City of Plymouth Planning Commission

Special Meeting Agenda

Thursday, July 17, 2025 – 7:00 p.m.
City Hall & Online Zoom Webinar

PUD 25-02: Starkweather Subdivision (behind 550 N. Holbrook), Planned unit development (PUD) amendment to allow lots 17, 18 and 19 to provide signage instead of privacy fences along the rear property lines. The property is zoned PUD, Planned Unit Development.

Figure 2. Original PUD Park & Trail Easement Benefits

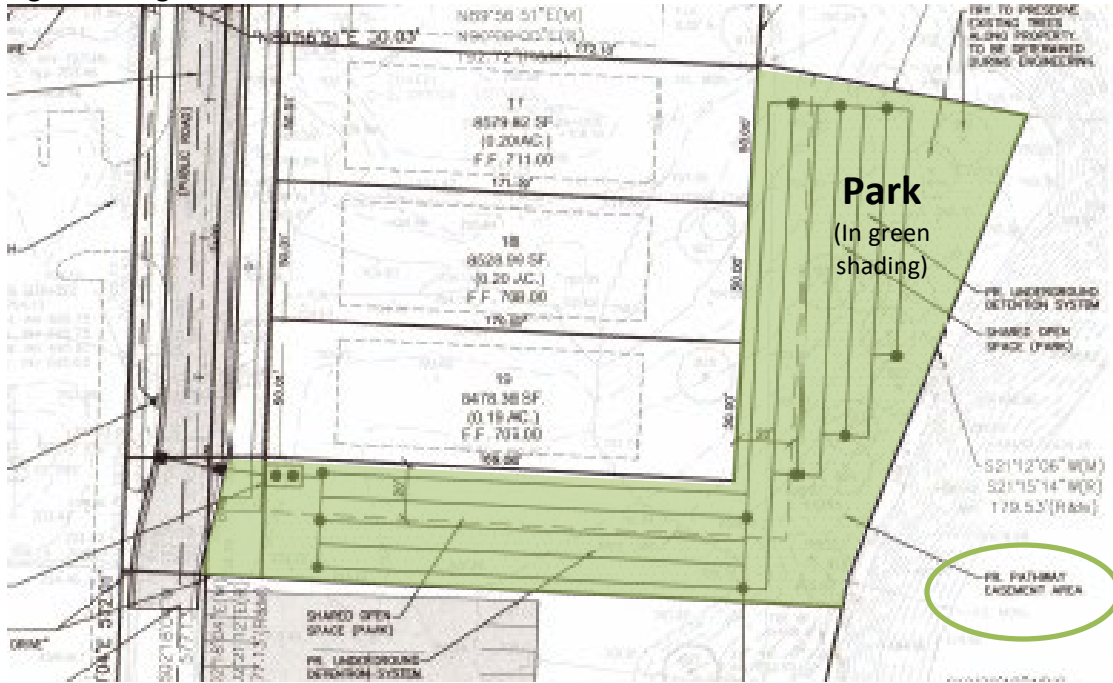
The fence adjacent to Lots #17 – #19 was required by the Planning Commission when the developer asked to build six parking spaces in the park. The land area of the three lots was reduced and added to the park to make up for the parkland occupied by the six parking spaces.

Figure 2: Proposed Park - Approved Amendment 2021 (left) and Existing Conditions 2024 (right)

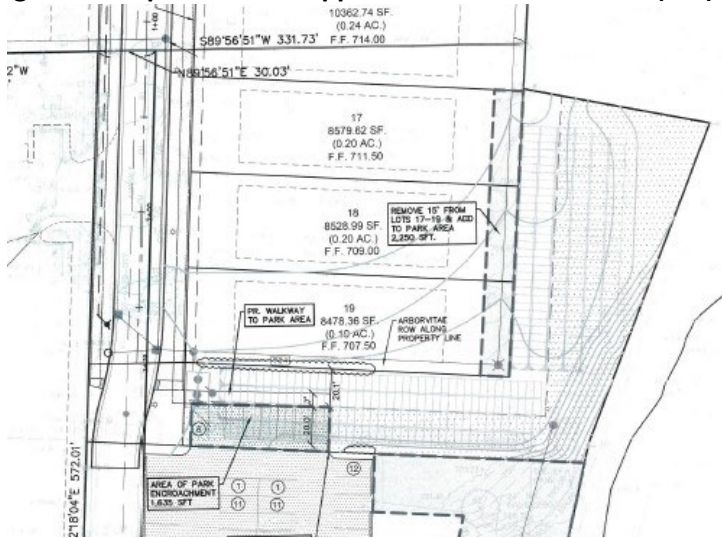
Regarding environmental impacts, the request to eliminate the fence behind units #17-19 is contrary to the 2021 First PUD Amendment, where additional park space was acquired from the rear portions of these lots. Another intent of the fence along the rear of these lots was to definitively identify where private property ends, and public property begins. As can be seen from a recent aerial photograph, it appears that landscaping of the new homes on lots #17 and #18 encroaches into the PUD park. This condition will need to be addressed by the developer to ensure the approved PUD plan is implemented.

EXTERIOR ELEVATIONS

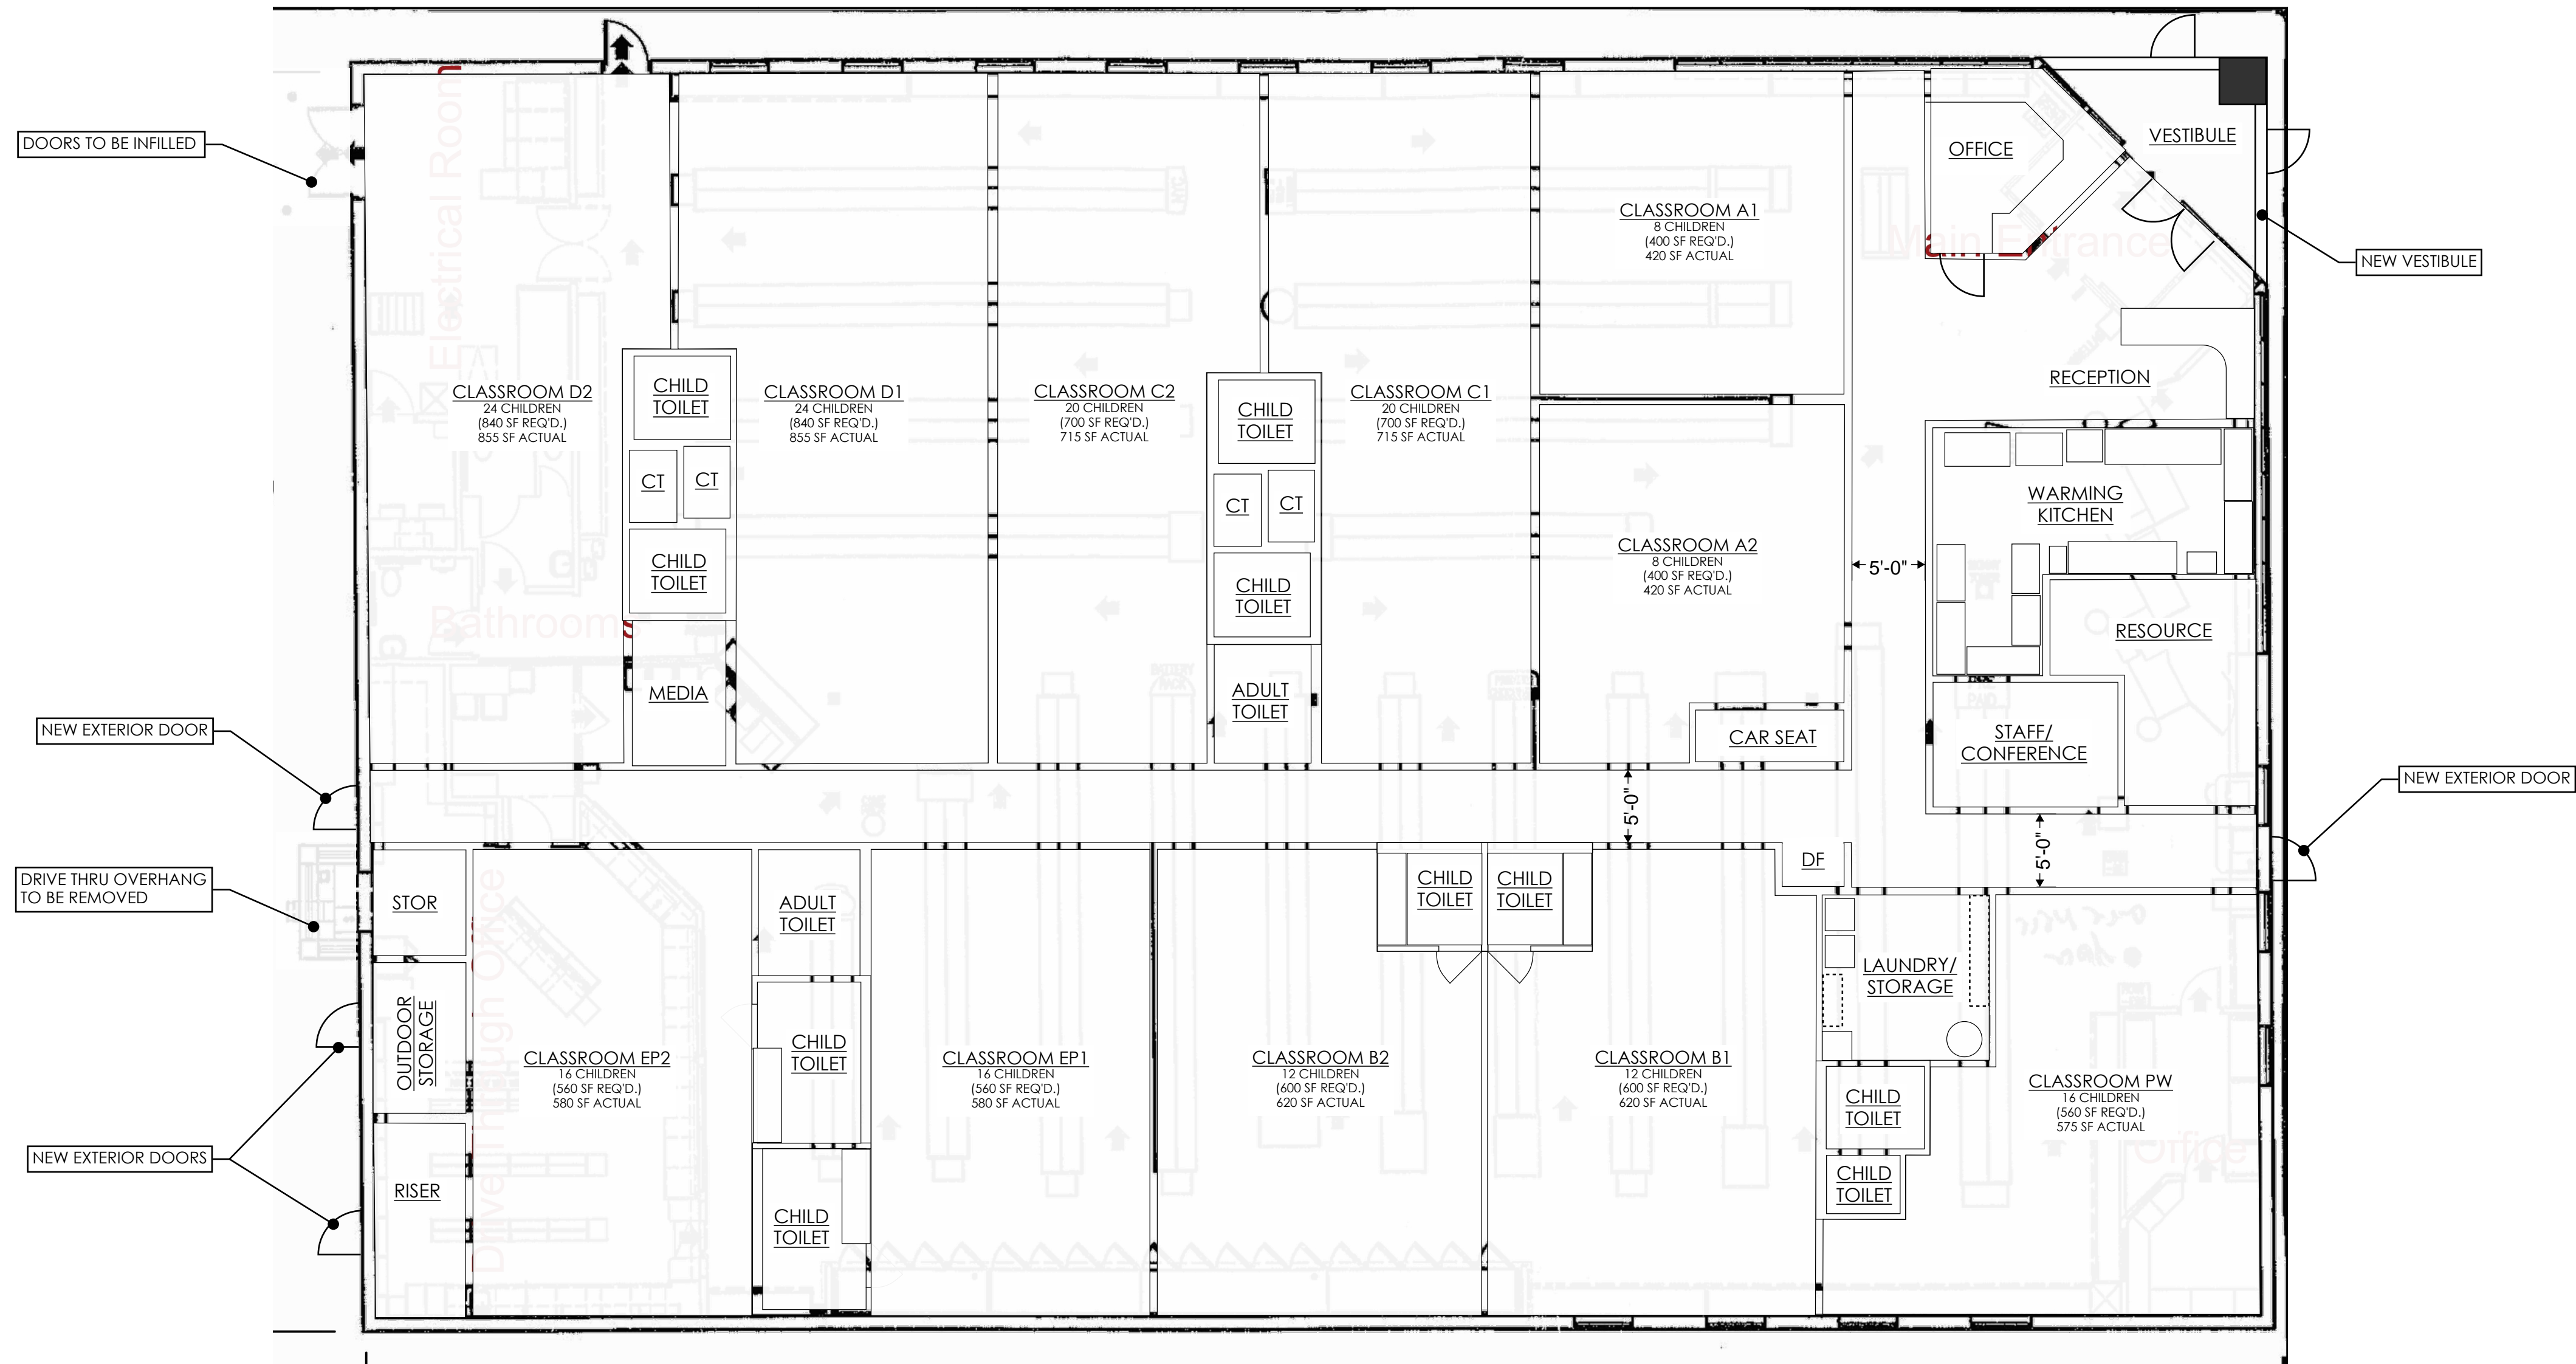
Dimensioned elevations are provided on Sheet A-2.0. The southeast corner of the existing building façade includes an angled entry portico; the proposed use is removing the portico and squaring the face of the south and east facades, adding windows and doorways. The drive-thru roof at the rear of the building is also being removed, and openings in this façade filled in with brick.
